TRAILER AIR SUSPENSIONS

TECHNICAL BULLETIN

No: 97117-158

Subject: Improved Reverse lock

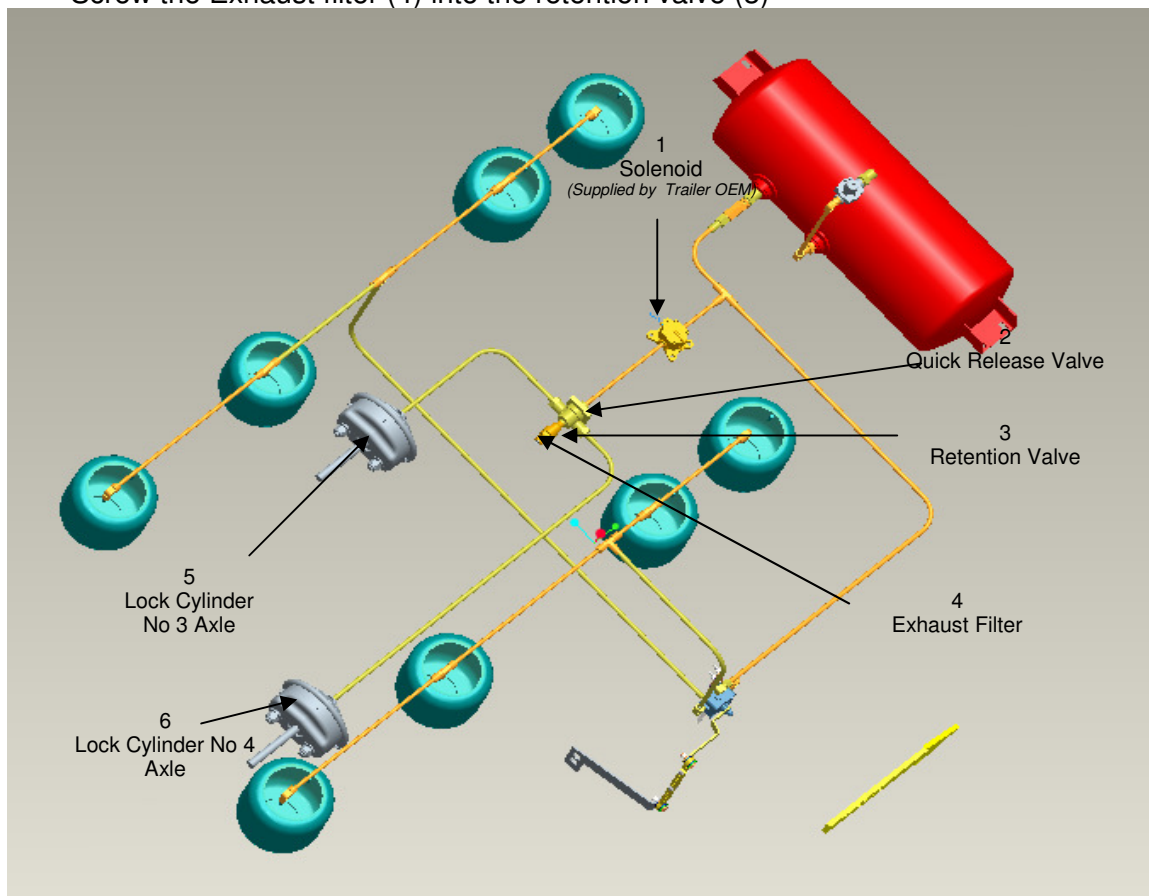
This kit is designed to improve the Reverse lock as fitted by the trailer OEM.

1. Mount the QR valve (2), ideally in a position between the two steer axles.
2. Take the supply from the Solenoid Valve (1) (Supplied by Trailer manufacturer) and couple it to the No1 (*top*) port on the QR Valve (2)
3. Take a air line from each of the Reverse lock air chambers and fix to the No2 and No3 ports on the QR valve. (*These will be the side ports*).
4. Fit the 3/8" – 1/4" BSP adaptor to the No 4 Port (*Not Shown*)
5. Screw the retention valve (3) into the adaptor.
6. Screw the Exhaust filter (4) into the retention valve (3)
